SUBJECT: Suggestion #CELMN920007 - Review of Need for Out-Year  
Levee Lifts -- Wave Runup

SUBJECT: Lake Pontchartrain La. and Vicinity Hurricane Protection Project Wave Design Criteria to be Used in Design of Proposed Breakwaters for Pumping Stations 2 and 3 Jefferson Parish, La.

# JEFFERSON PARISH LEVEE DESIGN WAVES, RUNUP, HEIGHT VS WINDSPEED

SUGGESTION FOR DESIGN REVIEW OF OUT-YEAR LEVEE LIFTS  
FOR NOD HURRICANE PROTECTION PROJECTS

## JEFFERSON PARISH LAKEFRONT LEVEE ANALYSIS

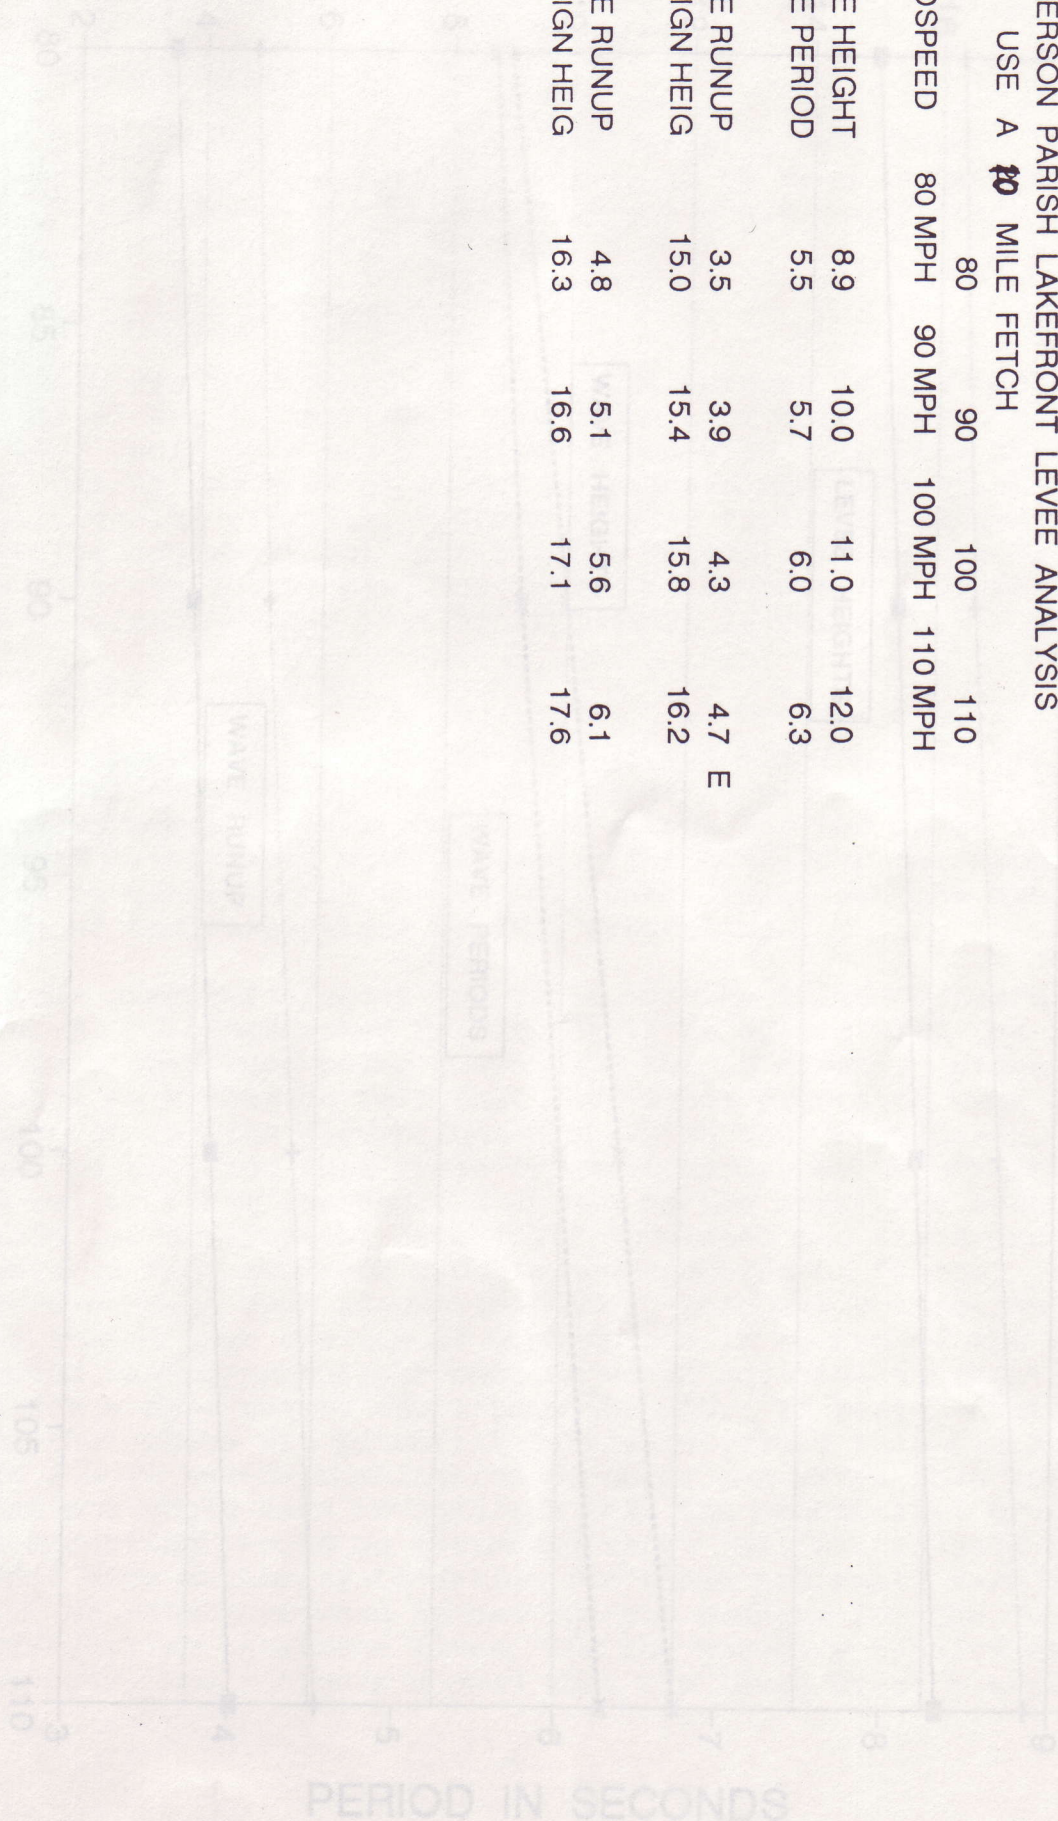
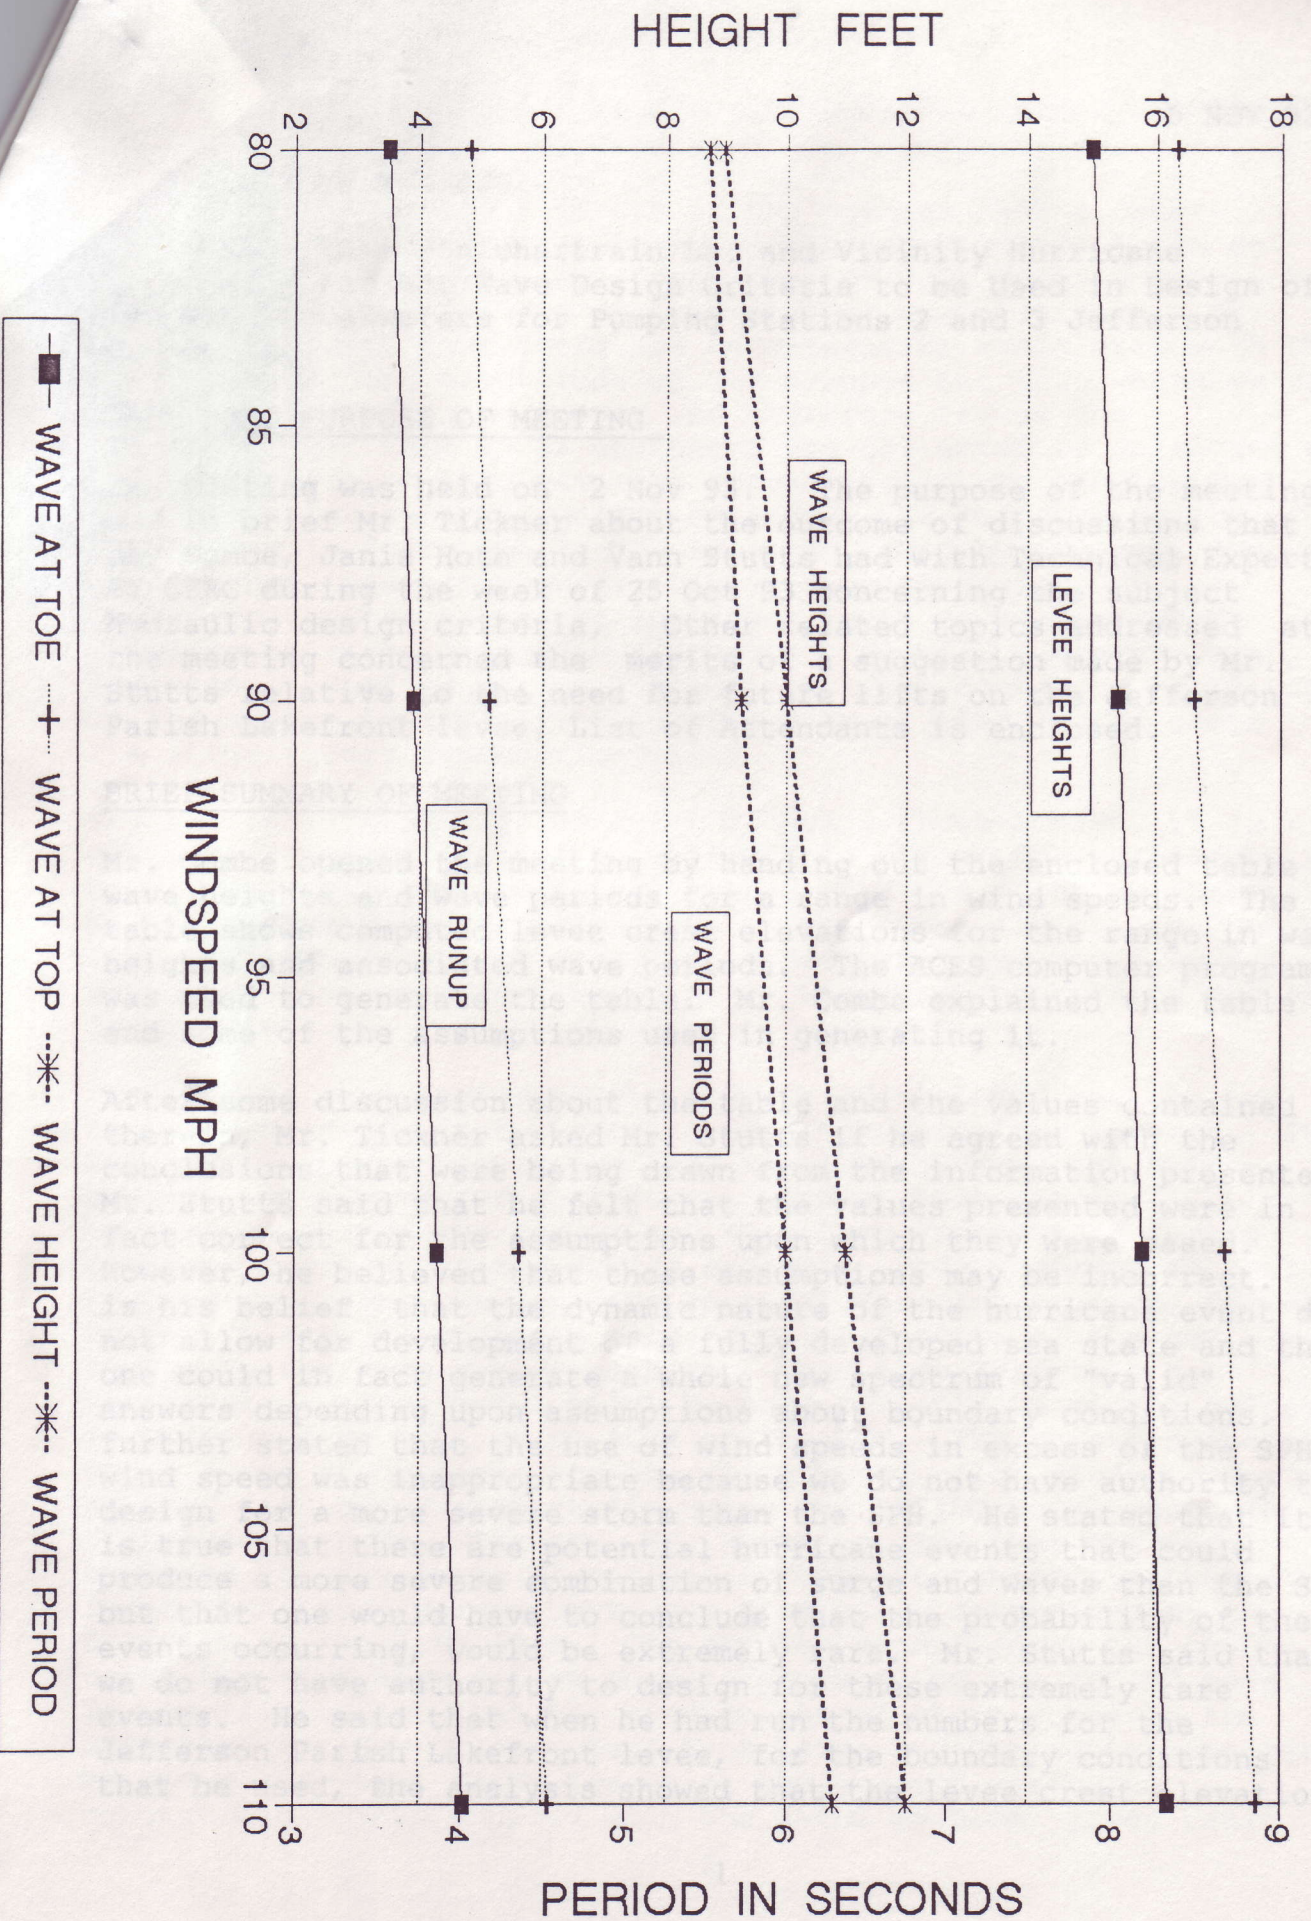
Mr. Combe opened the meeting by handing out the enclosed table of wave heights and wave periods for a range in wind speeds. The table shows computed levee crest elevations for the range in wave heights and associated wave periods. The ACES computer program was used to generate the table. Mr. Combe explained the table and some of the assumptions used in generating it.

After some discussion about the table and the values contained therein, Mr. Tickner asked Mr. Stutts if he agreed with the conclusions that were being drawn from the information presented. Mr. Stutts said that he felt that the values presented were in fact correct for the assumptions upon which they were based. However, he believed that those assumptions may be incorrect. It is his belief that the dynamic nature of the hurricane event did not allow for development of a fully developed sea state and that one could in fact generate a whole new spectrum of "valid" answers depending upon assumptions about boundary conditions. He further stated that the use of wind speeds in excess of the SPH wind speed was inappropriate because we do not have authority to design for a more severe storm than the SPH. He stated that it is true that there are potential hurricane events that could produce a more severe combination of surge and waves than the SPH but that one would have to conclude that the probability of these events occurring, would be extremely rare. Mr. Stutts said that we do not have authority to design for these extremely rare events. He said that when he had run the numbers for the Jefferson Parish Lakefront levee, for the boundary conditions that he used, the analysis showed that the levee crest elevation

could be as low as 14.0 feet n.g.v.d. but that conservatively 14.5 would probably be more adequate.

Mr. Laurent stated that he was of the opinion that a crest elevation of 16.0 feet was close enough and that if we can get our answers to within 1 or 2 feet then we were doing a good job. He stated that we are not dealing with an exact science. Mr. Stutts concurred that there are uncertainties associated with the methodologies and exactitude of the process but that where we can produce a more precise answer and therefore reduce the uncertainties, then we as engineers are obligated to do so and as civil servants we also have the responsibility to get the most protection for each tax dollar expended. He said the degree of protection in Jefferson Parish is established by the east and west return levees/floodwalls that are designed for SPH protection and to raise the lakefront levee to a point where these levee gives more than SPH protection will not provide any additional benefits to the project since the degree of protection in the system is established by the weakest link in the chain, i.e., the return levees/floodwalls.

Relative to the question about the Proposed Breakwaters for Pumping Stations Nos 2 and 3 in Jefferson Parish, it was agreed that the design height for the structure at Pumping Station No. 3 should be elevation + 6.0 feet n.g.v.d. and that we will use an elevation of + 14.0 n.g.v.d. at Pumping Station No. 2. These values will be used to prepare designs and cost estimates for the DM. Mr. Tickner approved the go ahead for the Coastal Engineering Section to proceed with in-house resources to do the 2-D wave study using the SHALWAV program in Lake Pontchartrain. It was agreed that if the wave study showed a substantially different result than was used to design the breakwaters, then we would modify the design during the Plans and Specification for the breakwater. It was also pointed out that if the wave study supported Mr. Stutts contention about the lack of need for future lifts on the Jefferson Parish Lakefront levee then we would need to revisit Mr. Laurent's decision to reject the suggestion. The urgency to make a decision about the suggestion is not great since there are no proposed lifts in the immediate future for this levee.
